# MISSISSIPPI POWER & LIGHT COMPANY

SUBJECT: Grand Gulf Nuclear Station  
Units 1 and 2  
Docket Nos. 50-416 and 50-417  
File: 0260/L-350.0  
Transmittal of Corrections to SER  
AECM-82/209

Attached for your consideration is a proposed revision to SER Chapter 17. This revision is provided to clarify the organizational and programmatic policies outlined in MP&L's Operational Quality Assurance Manual, MPL-TOP-1A, which has been accepted by the NRC.

MP&L OPERATIONAL QUALITY ASSURANCE PROGRAM  
ORGANIZATION FIGURE 17.2-1

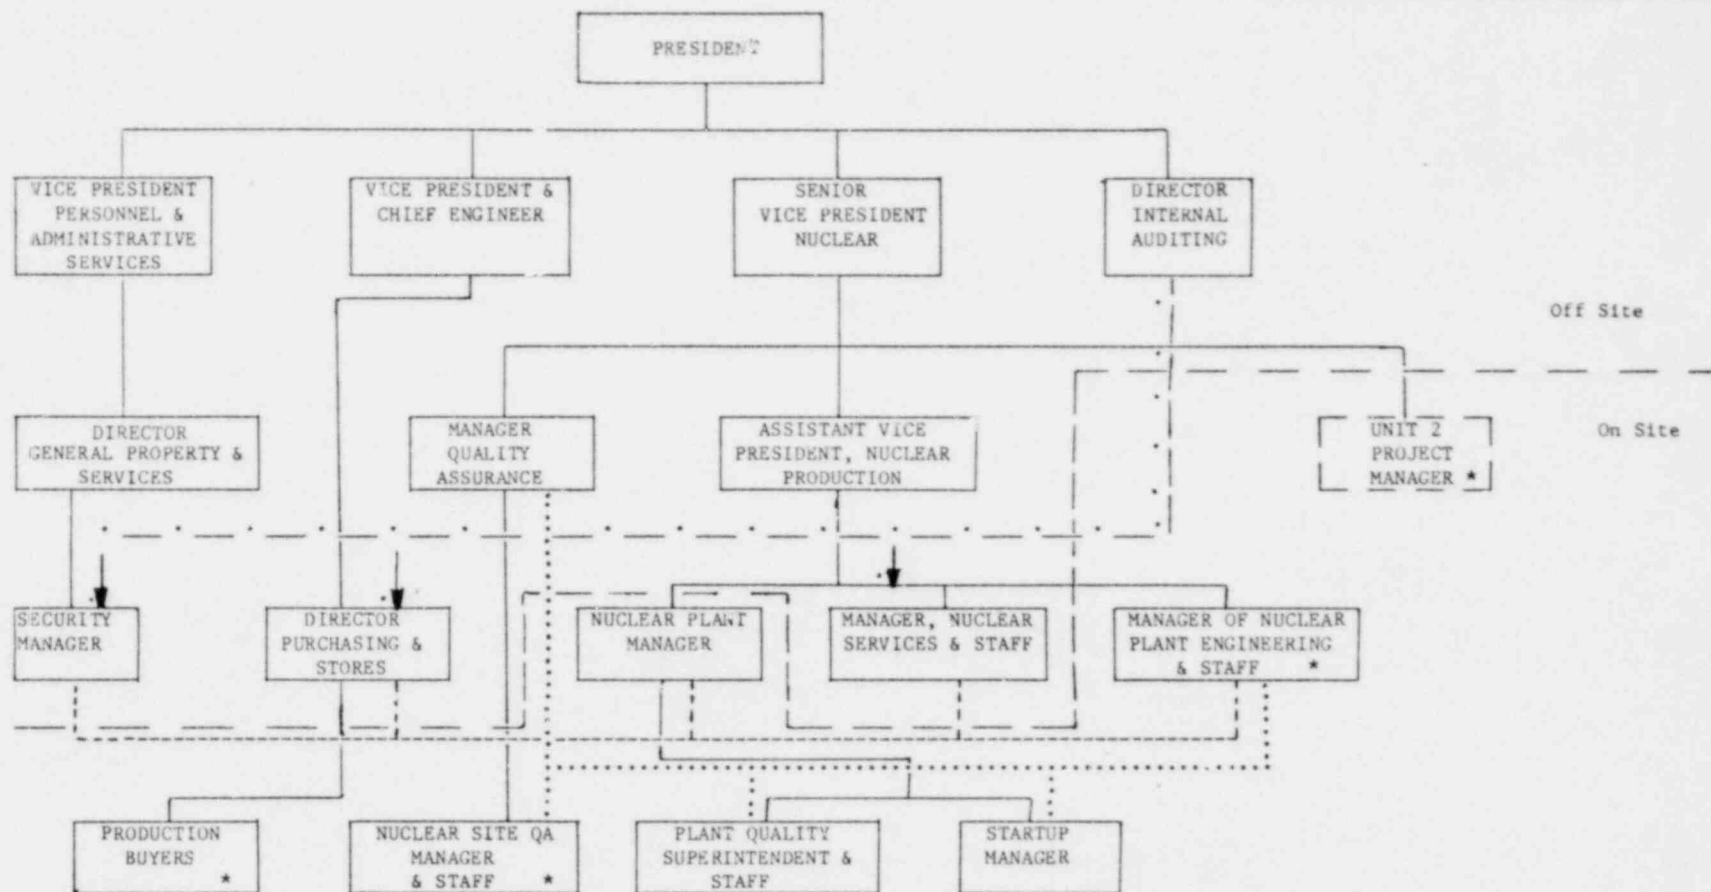
Mississippi Power & Light Company (MP&L) has conducted a review of Chapter 17 of the Grand Gulf Safety Evaluation Report (SER) (NUREG-0831). This review has revealed certain items which require clarification due to organizational changes within MP&L.

The structure of the organization responsible for the operation of Grand Gulf Nuclear Station, Units 1 and 2, and for the establishment and execution of the operational phase QA program is shown in Figure 17.1. The Senior Vice President - Nuclear, who reports to the President, has been delegated ultimate responsibility for the safe and reliable operation of the Grand Gulf Nuclear Station. He provides guidance and Corporate QA policies, goals, and objectives to the Manager of Quality Assurance.

The Manager of Quality Assurance reports directly to the Senior Vice - President - Nuclear and is delegated the overall responsibility for establishing, controlling, and verifying the implementation and adequacy of the QA program. He is assisted in carrying out his responsibilities by onsite (Nuclear Site Quality Assurance Manager and Staff) and offsite QA personnel.

The Nuclear Plant Manager reports to the Assistant Vice President, Nuclear Production and is directly responsible for assuring the safe, reliable, and efficient operation of the plant and for assuring the implementation of MP&L's QA Program at the plant.

The Plant Quality Superintendent reports directly to the Nuclear Plant Manager and maintains a working interface and direct communication with the Manager of Quality Assurance and the Nuclear Site Quality Assurance Manager. The Plant Quality Superintendent is responsible for assuring implementation of MP&L's QA program at the plant. He independently evaluates and reports the status and effectiveness of the QA program at the station to the Nuclear Plant Manager and the Manager of Quality Assurance.
